Service Bulletin

Category S	Applicable Model/s 1988-'91 626	Subject PASSIVE SHOULDER BELT DOOR SWITCH HARNESS MODIFICATION	Bulletin No. 013/91 Issued 8/8/91 Revised
---------------	------------------------------------	--	---

Figure 1: Door Switch Harness Wire Location

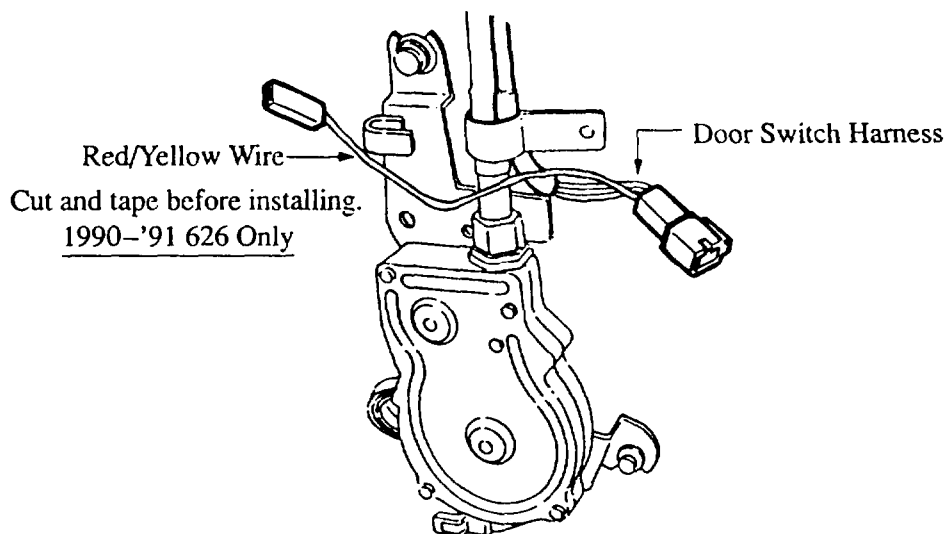
Replacement passive shoulder belt assemblies have a red/yellow wire from the limit switch connector. This wire plugs into the door catch connector on 1988 and '89 626 models.

There is no car-side harness plug for this wire on 1990 and '91 626 models. When replacing this assembly on 1990 and '91 626's, cut the wire and tape it to prevent short circuits from occurring. **Figure 1.**

Red/yellow wire applies to 1988 and 1989 626 models only.
